**ROGERS MS CENTRAL KITCHEN
A#03-124869
ADDENDUM 1 NARRATIVE**

AS REVISED
ADDENDUM 1
DSA #03-124869

LESD WILL ROGERS MS CENTRAL KITCHEN HVAC UPGRADES
LAWDALE ELEMENTARY SCHOOL DISTRICT
4110 W 154TH ST., LAWDALE, CA 90260

MECHANICAL
FIRST FLOOR
PLAN

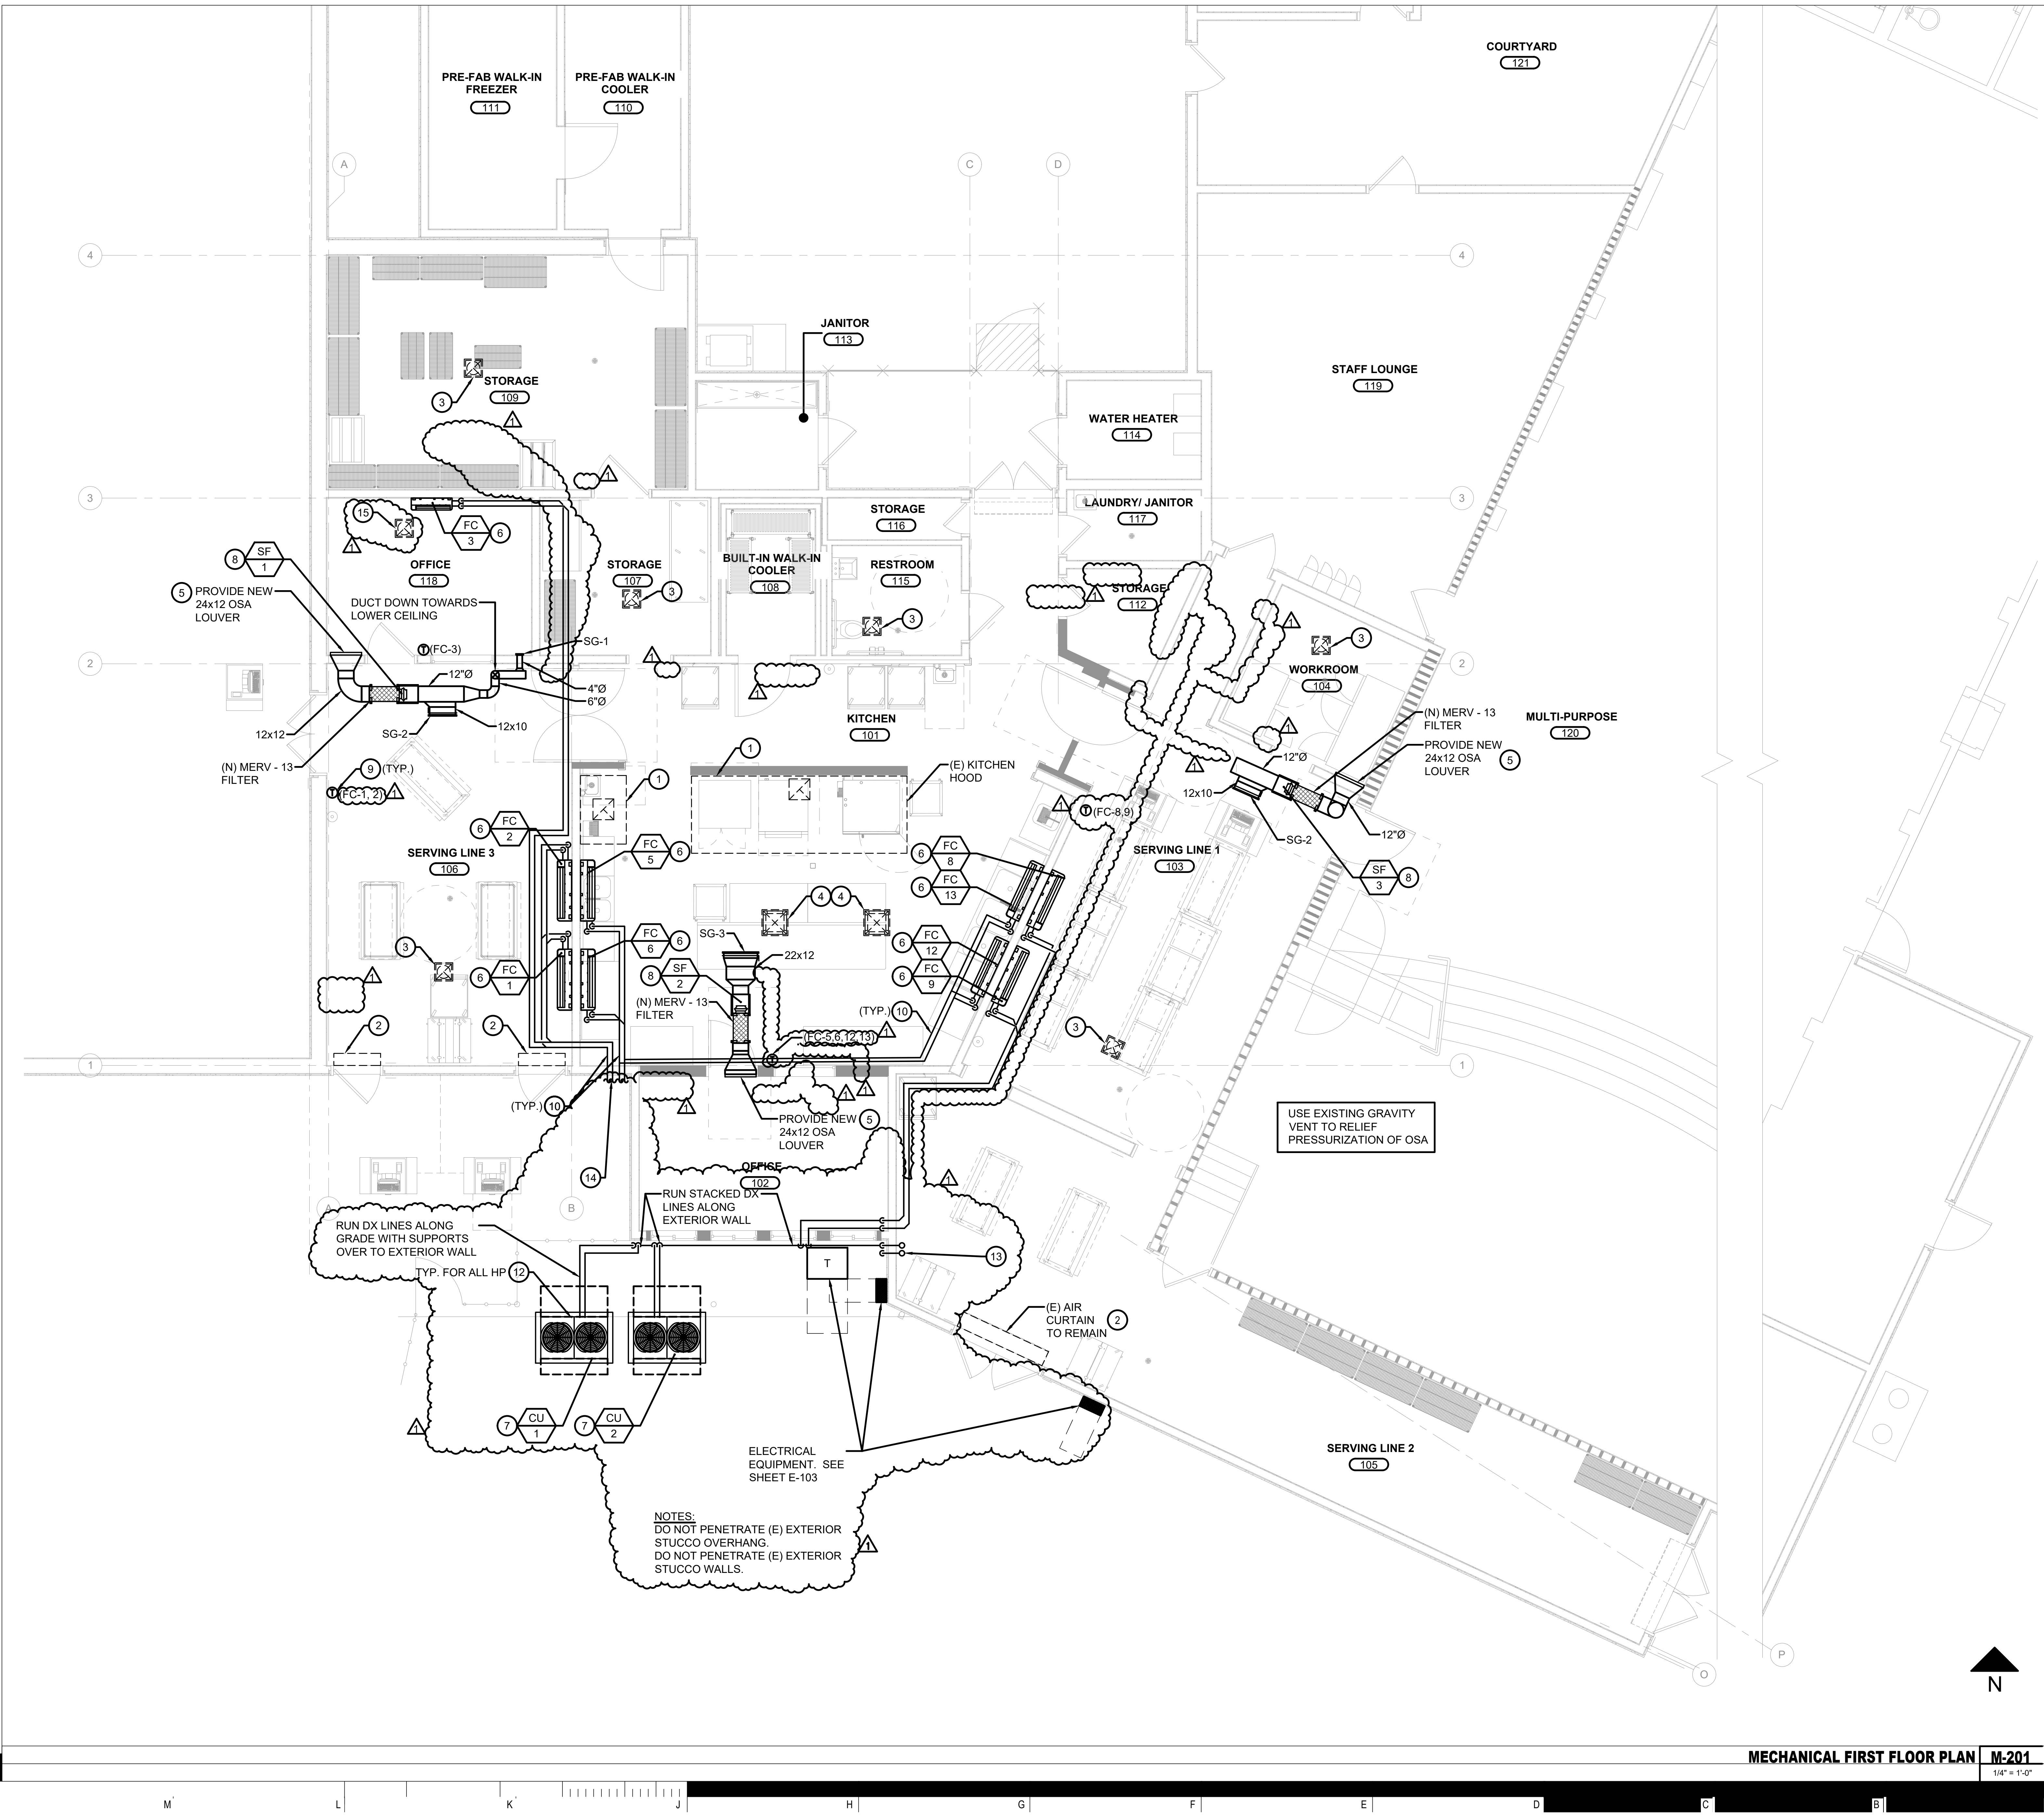
- 5. M-201 MECHANICAL FIRST FLOOR PLAN**
- a) Added Remodel Keynotes 13, 14 and 15.
 - b) Relocated outdoor CU units so they aren't underneath the existing overhang.

- c) Revised refrigerant piping routing.
 - d) Added note to not penetrate existing exterior stucco overhang or existing exterior stucco walls.
 - e) Removed FC-4, 7, 10 & 11 and associated tstats & refrigerant piping.

- f) Removed supply air to Workroom 104, Storage 112 and Storage 109.
 - g) Reduced amount of thermostats in the Serving Lines and Kitchen.
 - h) Relocated Electrical equipment shown for reference and coordination purposes.

MECHANICAL FIRST FLOOR CONDENSATE PLAN

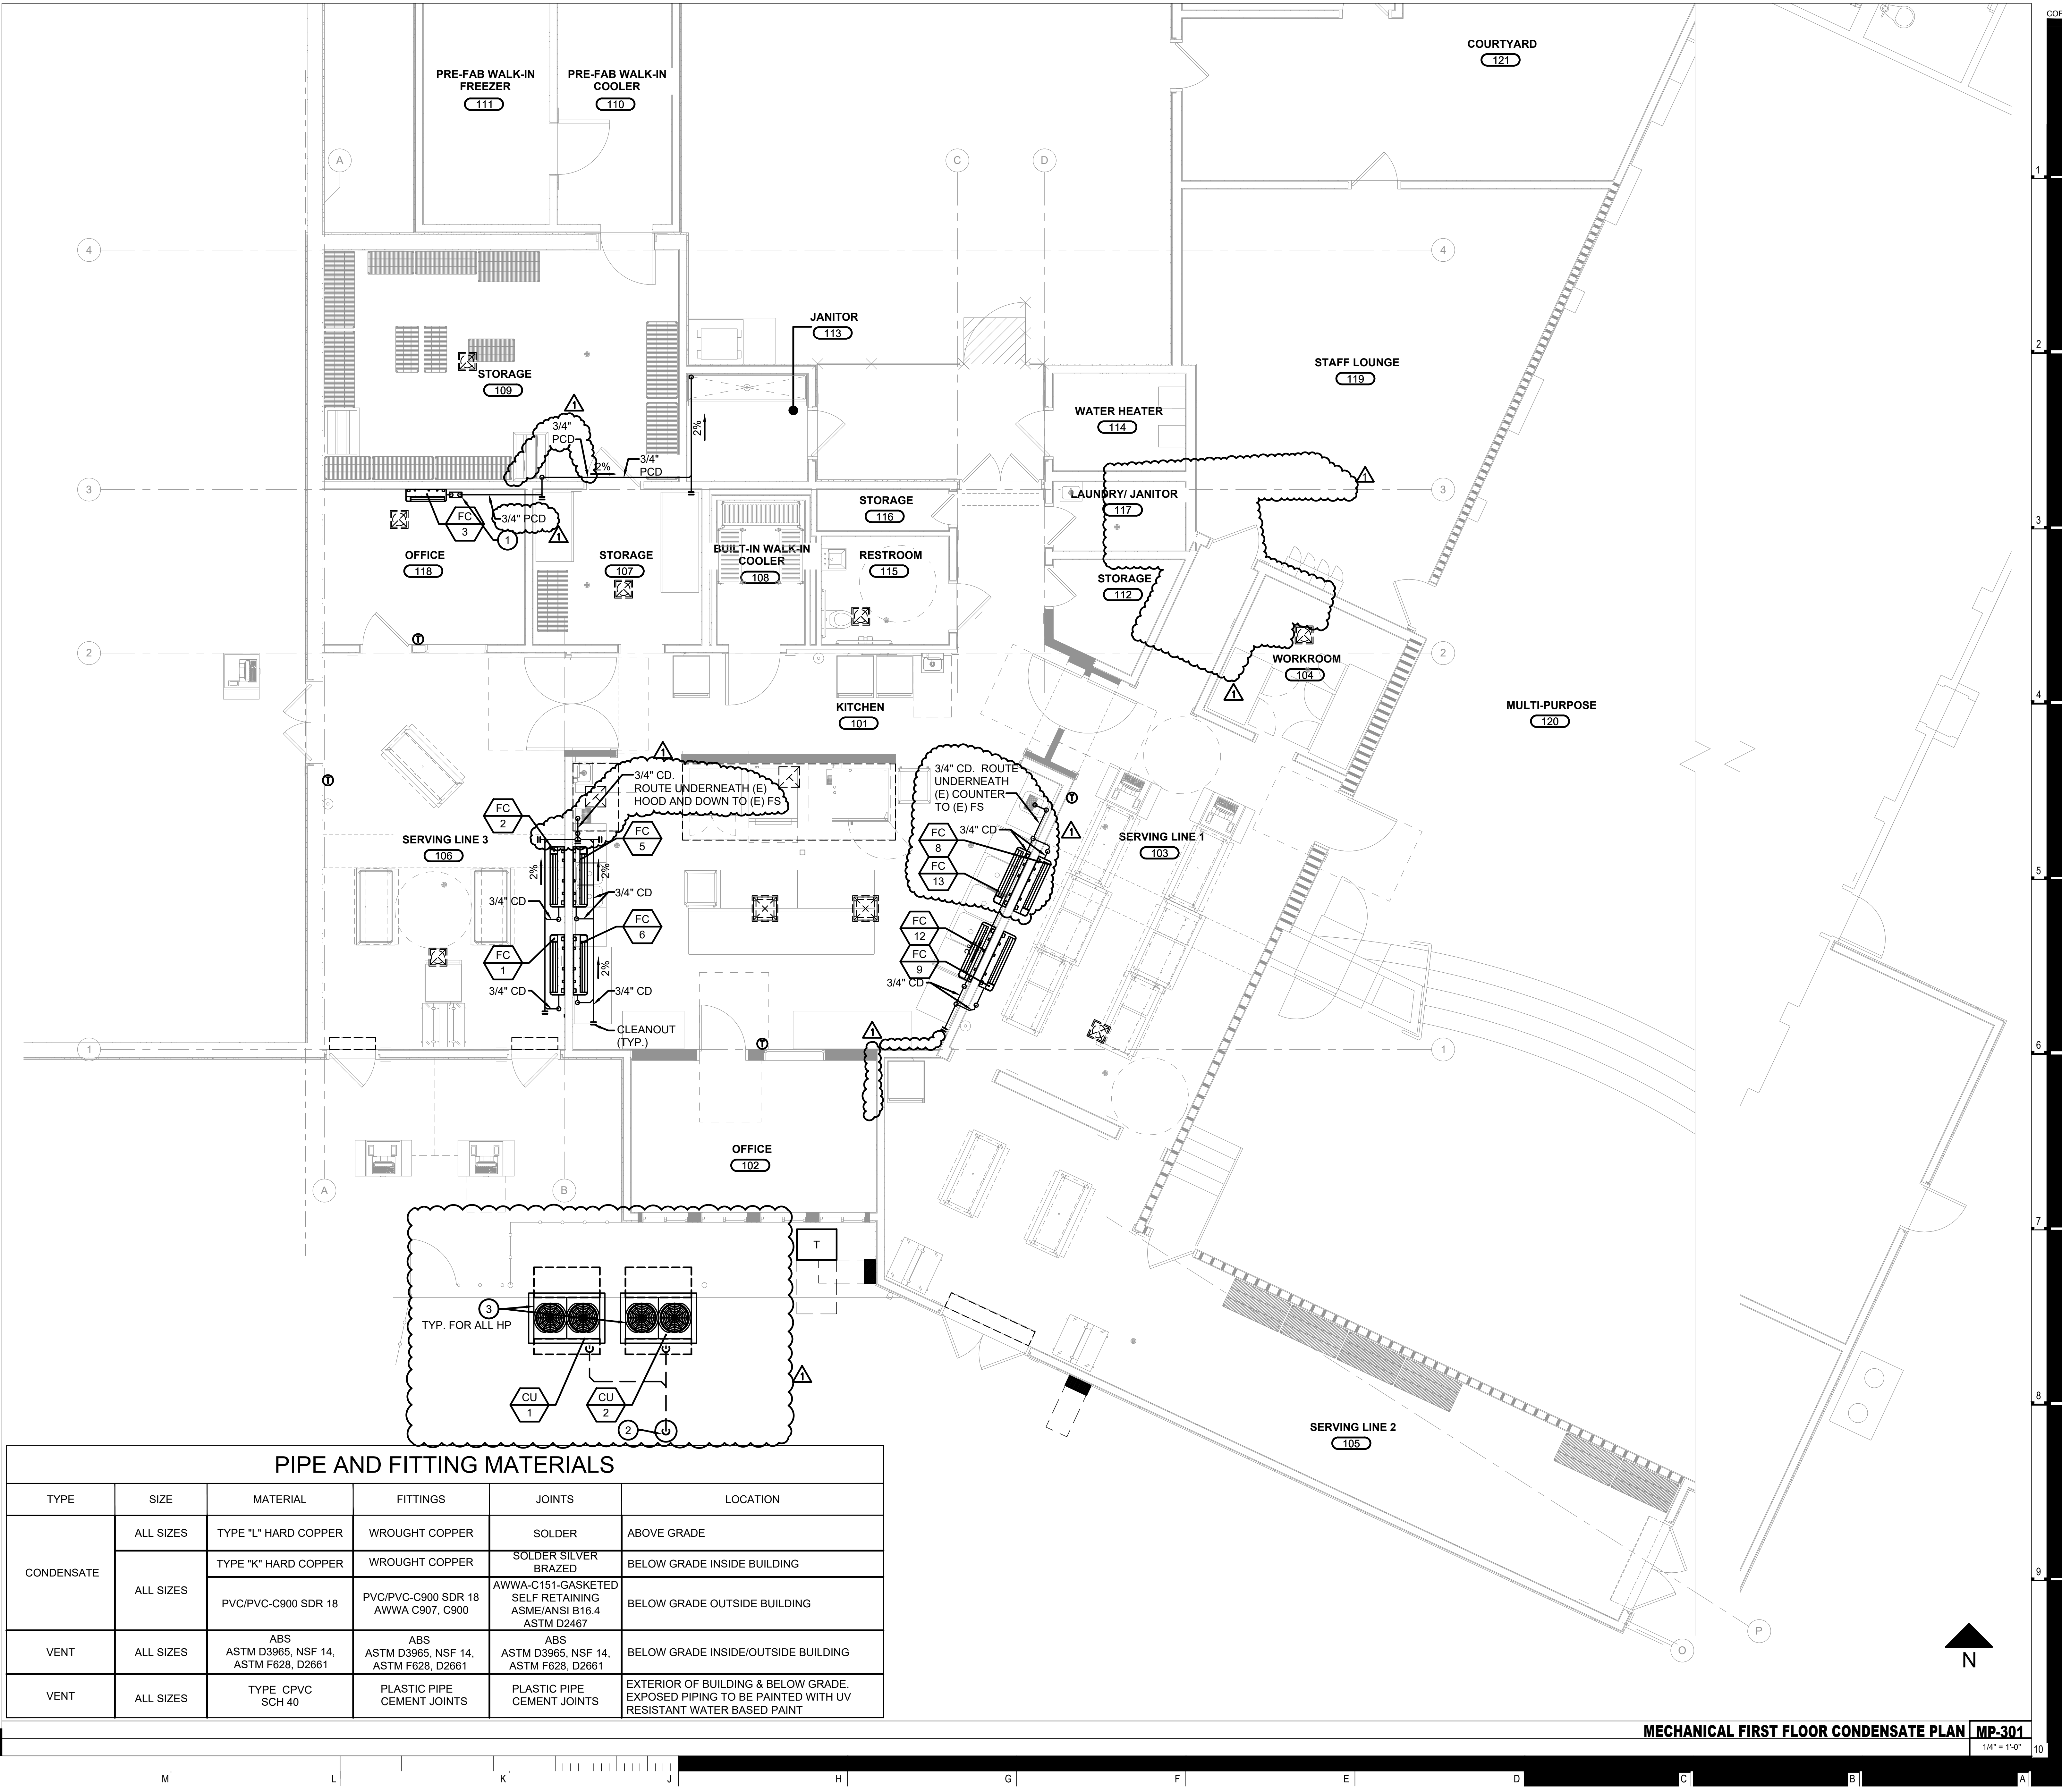
6. **MP-301 MECHANICAL FIRST FLOOR CONDENSATE PLAN**

- a. Added General Note 'B'.
- b. Revised Remodel Keynotes #1 and #3. Removed Remodel Keynotes #4, #5 and #6 and indicated them as "Not Used".
- c. Revised location of outdoor CU units and method of drainage. Removed underground vents that were serving the CU's.
- d. Clarified Pumped Condensate (PCD) locations.
- e. Clarified routing of gravity drained condensate to the existing floor sinks in Kitchen 101.

FCU CONDENSATE REMOVAL DETAIL

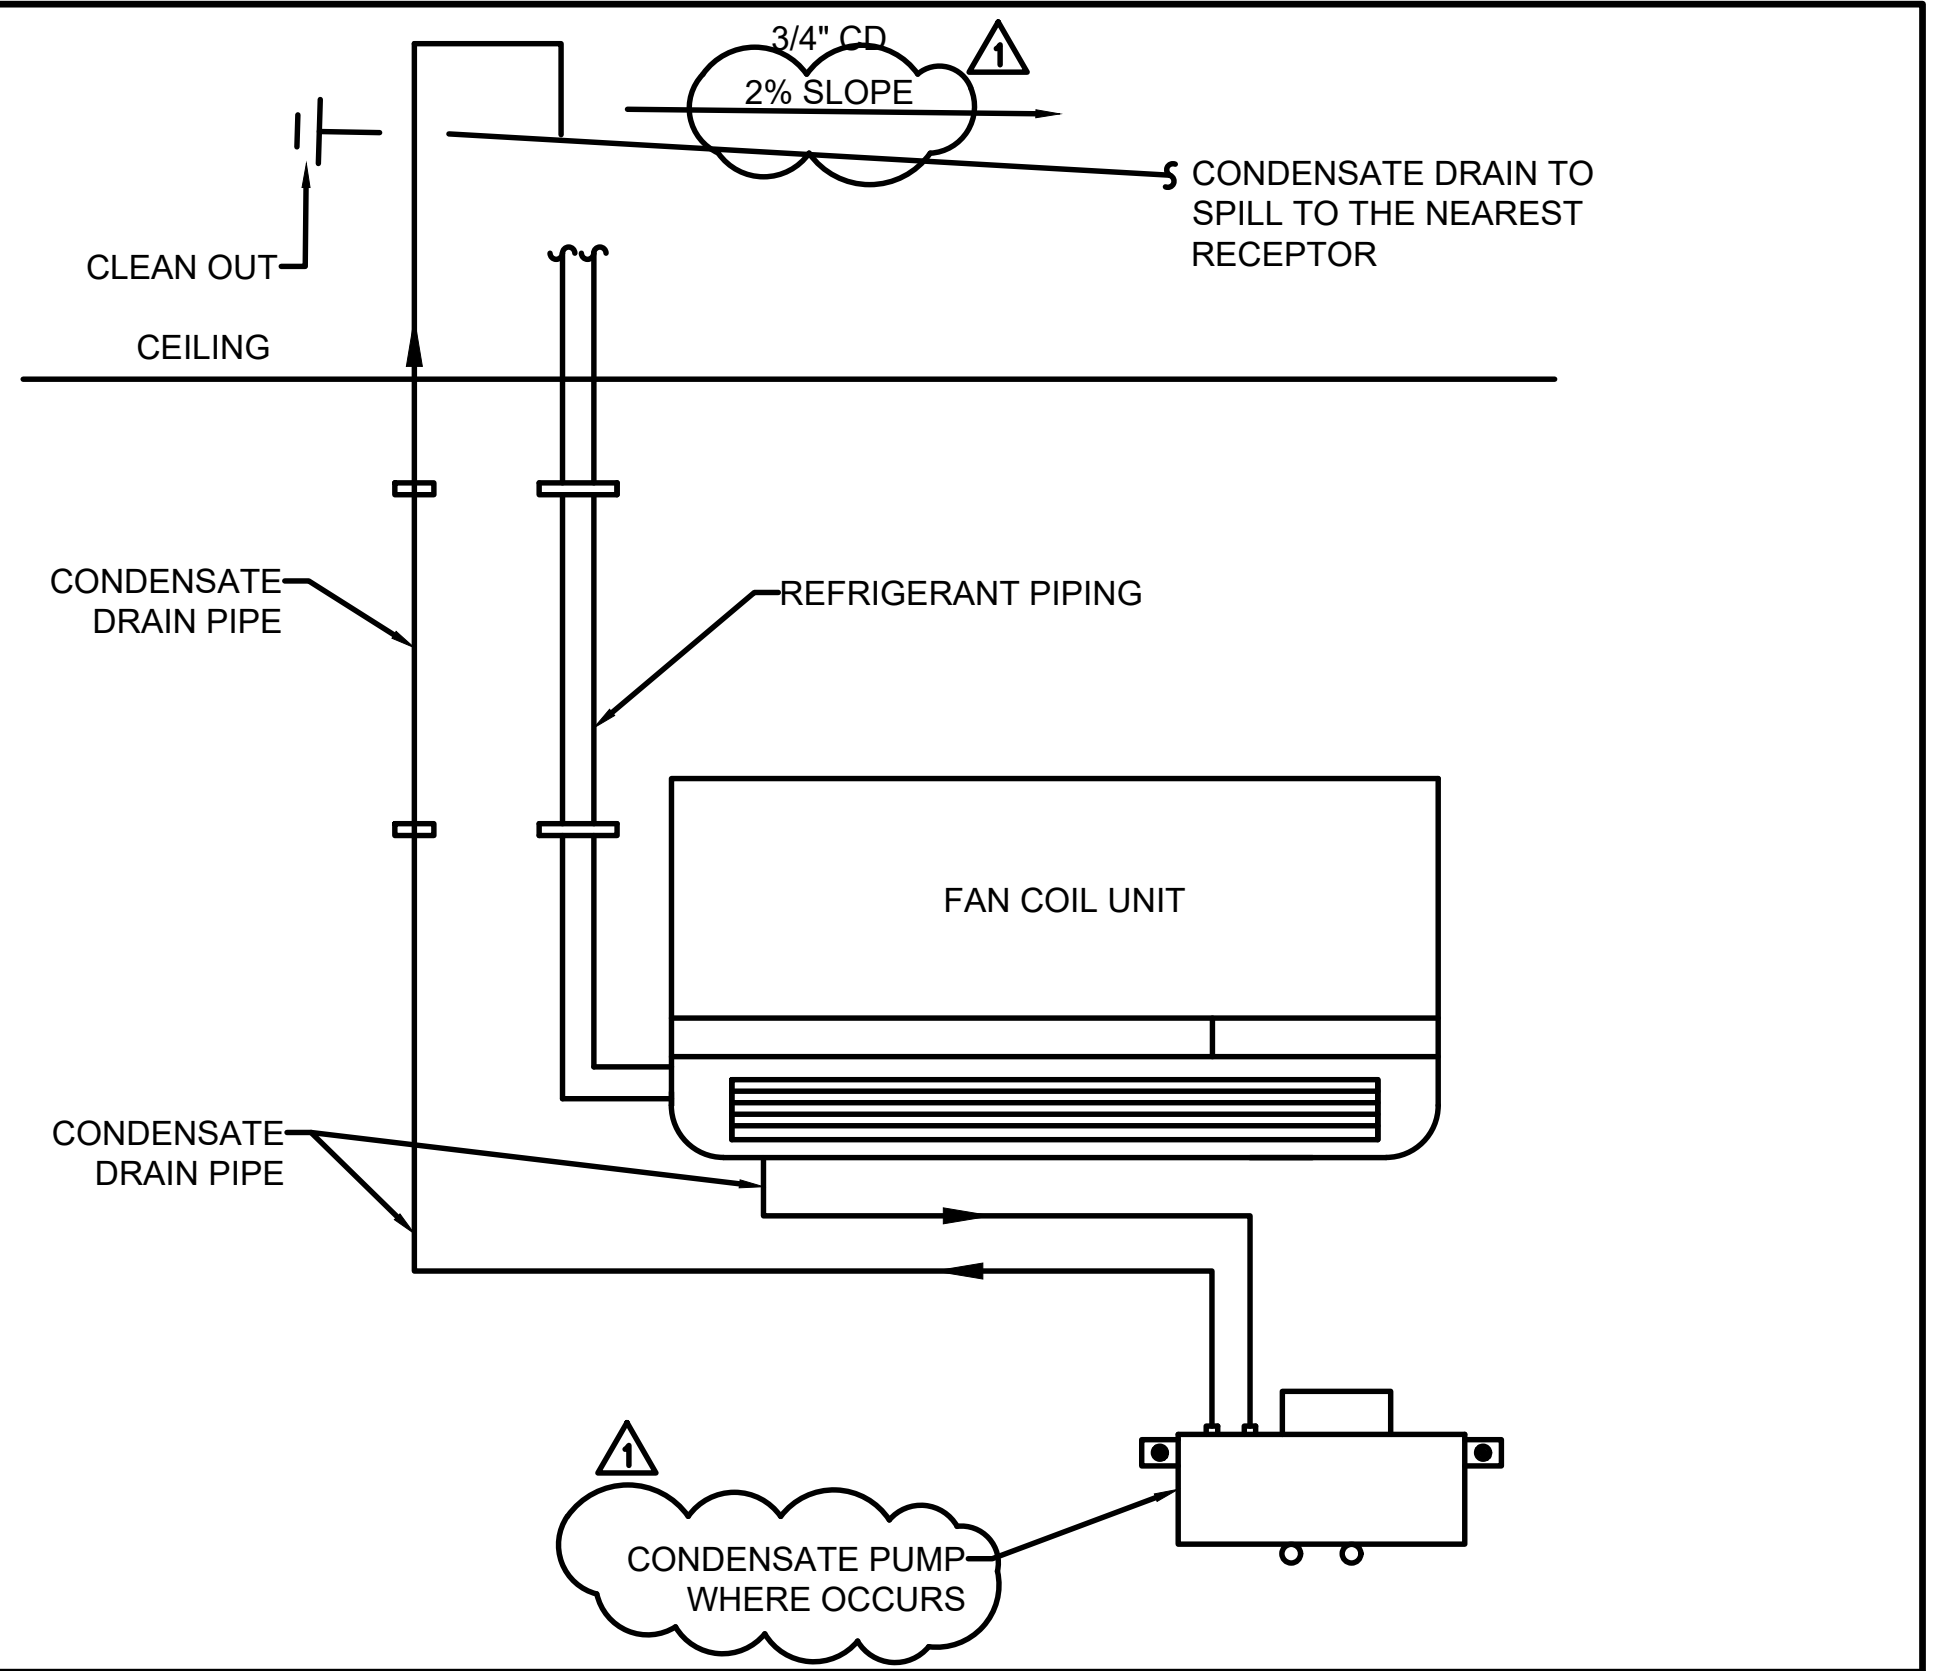
- a) Revised Detail 1 – FCU Condensate Removal Detail so the CD slope is revised and clarified the condensate pump.
- b) Revised Detail 3 to remove language referencing "Architect".
- c) Added Detail 4 - Condensate Drain to (E) Lav or Mop Sink.
- d) Revised Detail 6 - Outdoor Unit – CD Connection Detail so the draining method is simplified.
- e) Revised Detail 7 – Outdoor Unit Mounting Detail so the galvanized sheet metal pan is mounted directly to the concrete pad. Added note for scarification and clarified the drain pan and anchorage method.
